**THE APEX - LH
'GEORGIAN'**

5-10-24 - INITIAL REDLINES - JJ

5-22-24 -Add Foundation Dimension & Roof Pitch Adjustment on the Garage roof - JJ

SHEET
2.8.2b

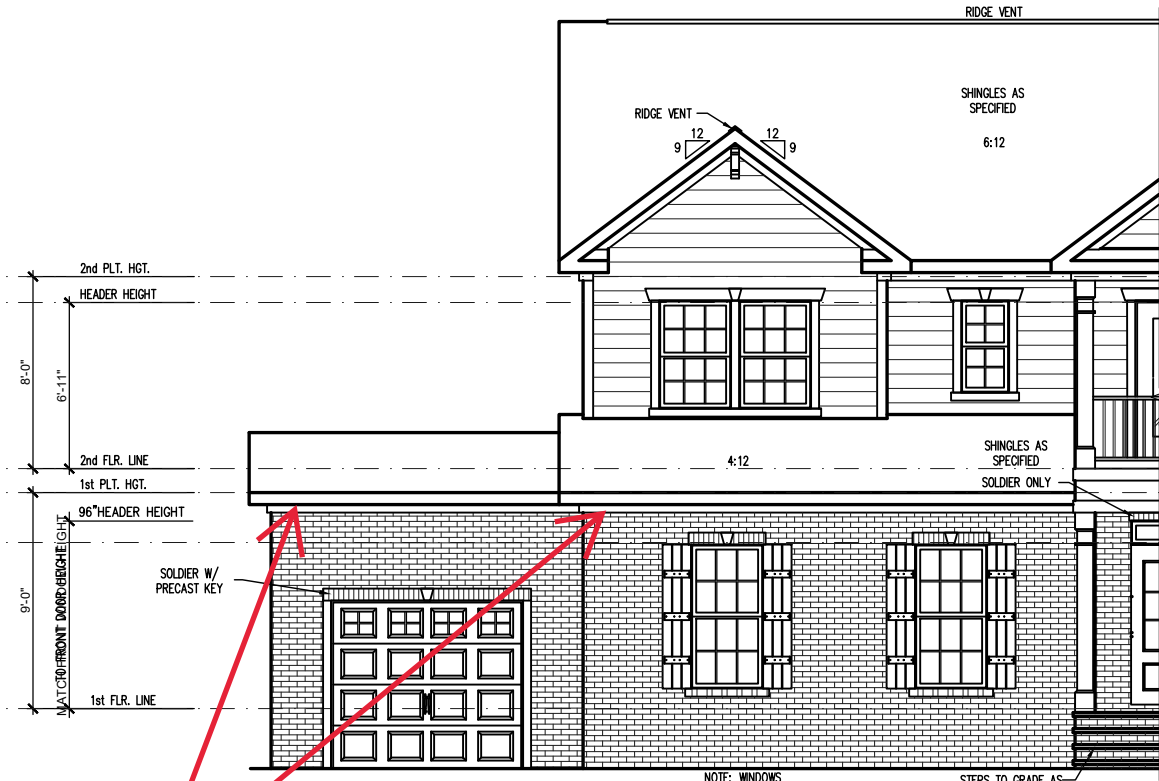
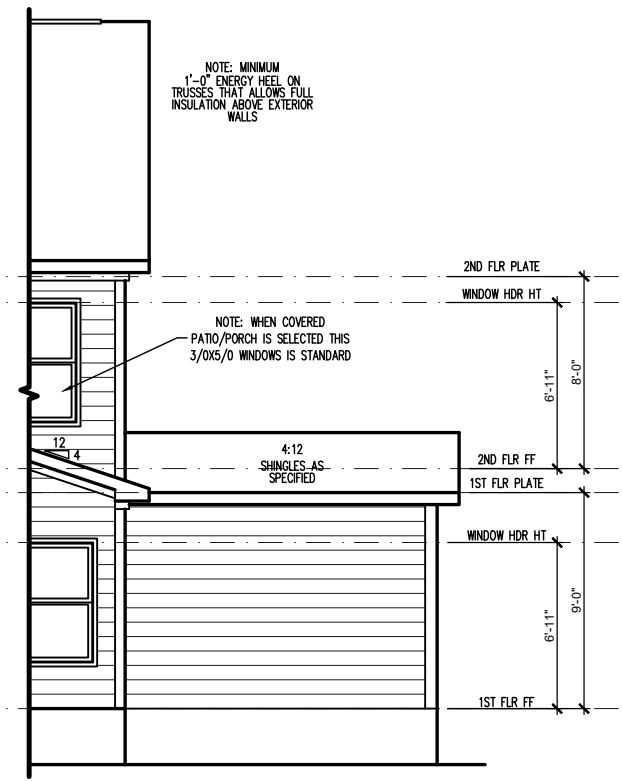
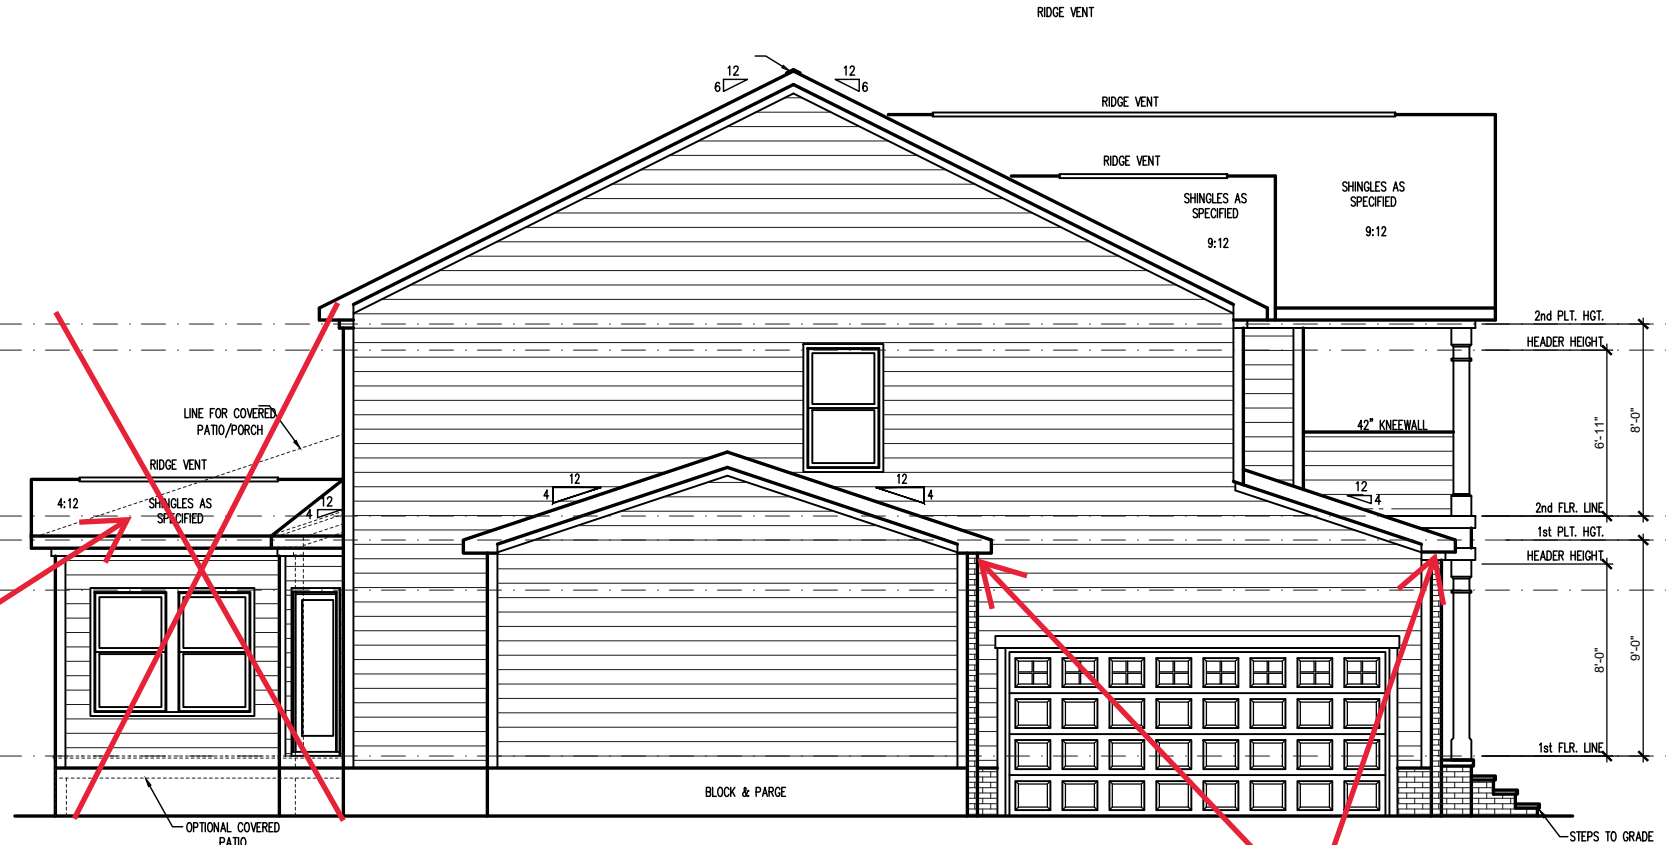
See Sheet 2.4.3 for cov porch with sitting at second floor

FRONT ELEVATION 'GEORGIAN' (CRAWL/STEM WALL)
 SCALE: 1/4" = 1'-0" ON 22x34, 1/8" = 1'-0" ON 11x17 SEE FOUNDATION PAGES FOR FOUNDATION TYPE

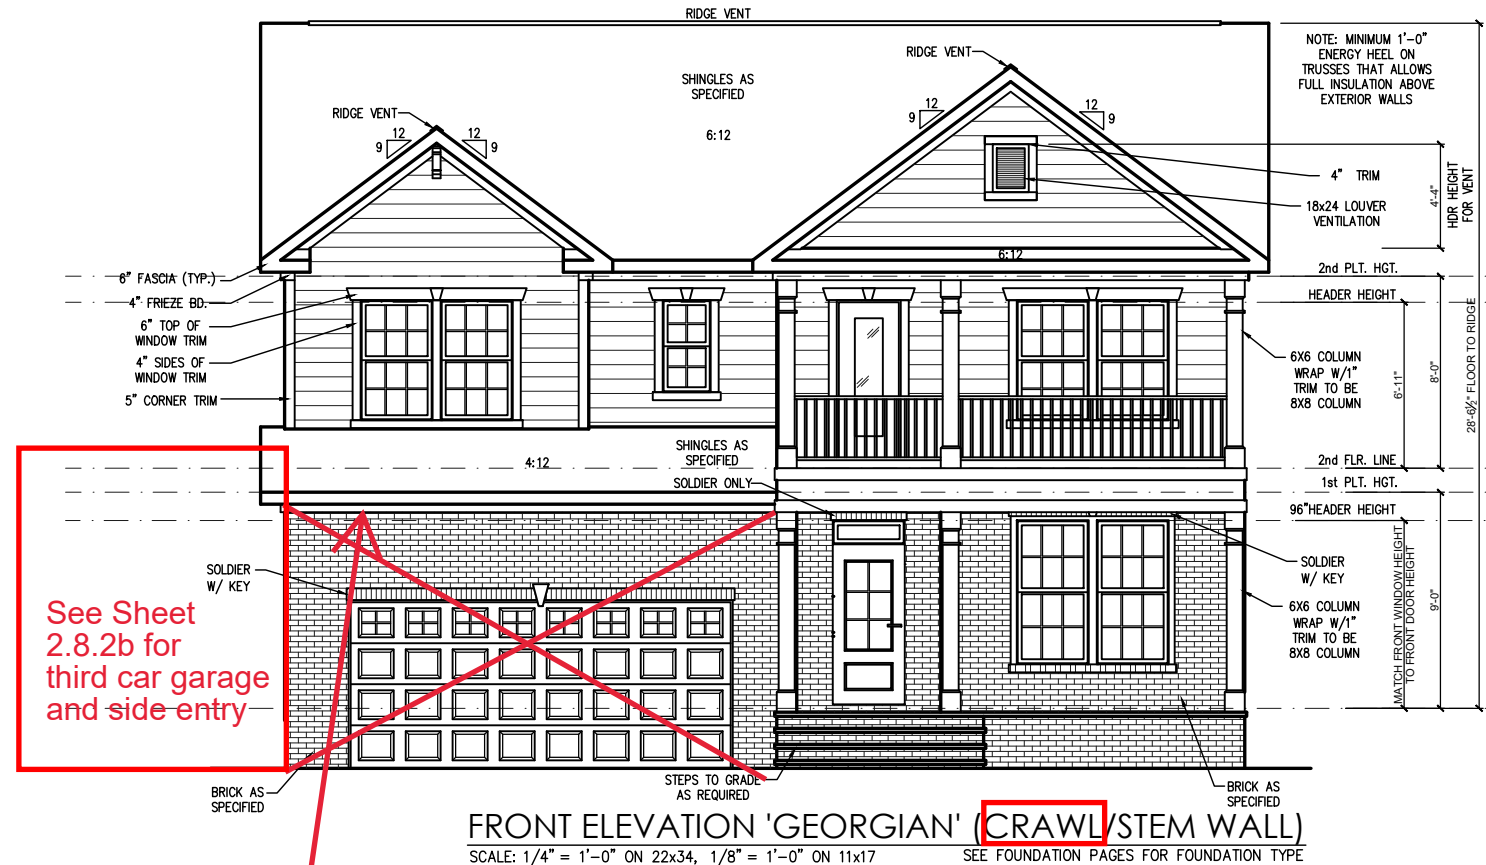
See Sheet 2.8.2b for third car garage and side entry

S-2.4.2a

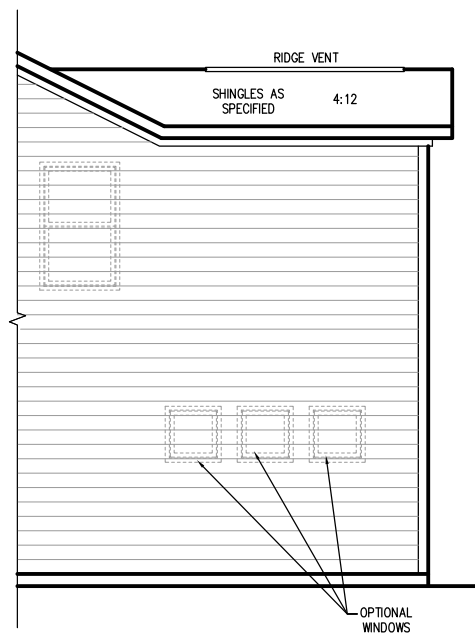
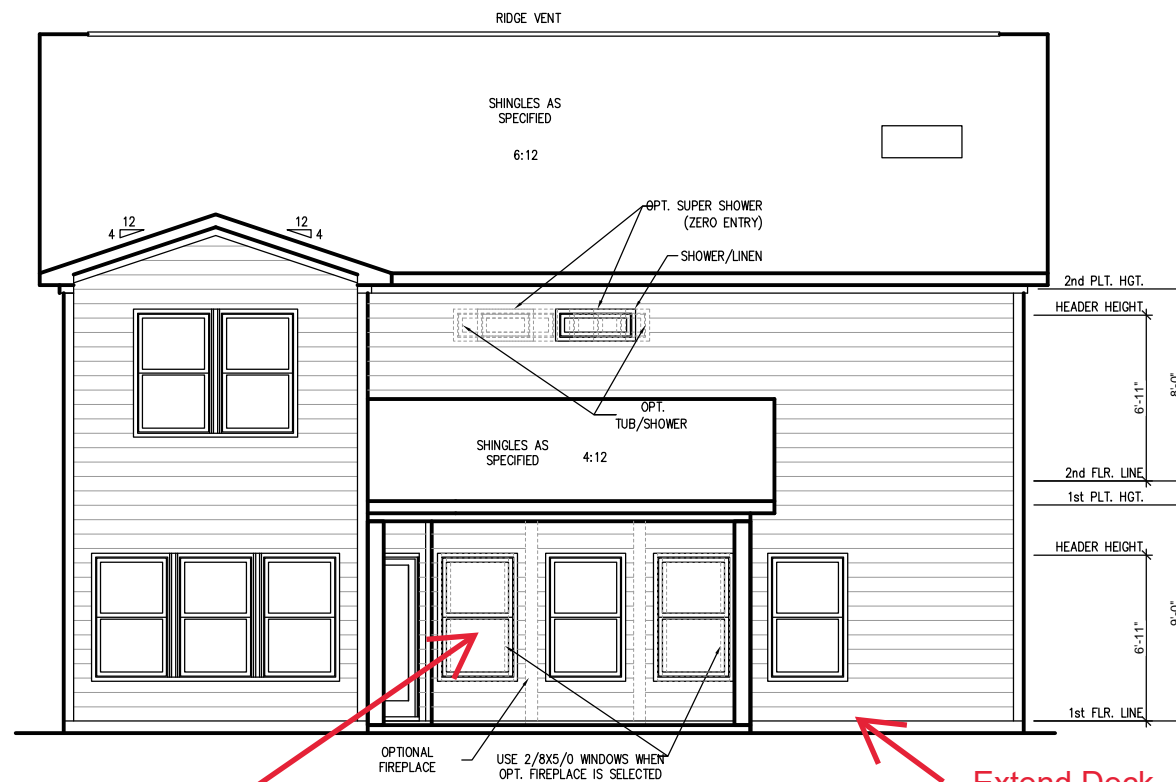
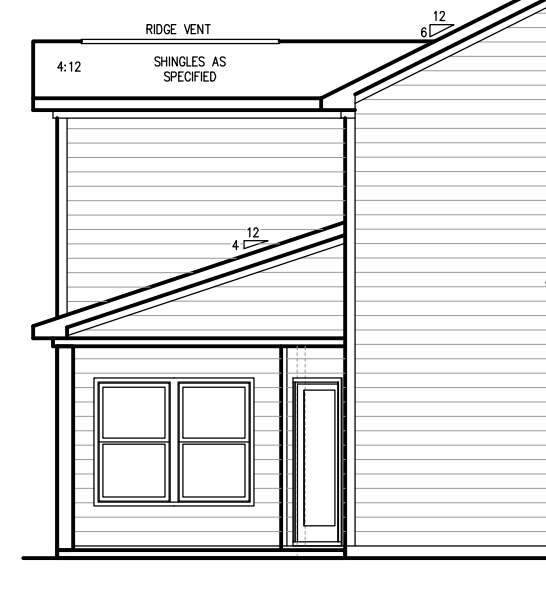
Porch to be Screened in

Extend Deck (Uncovered)

To be on a crawl space foundation
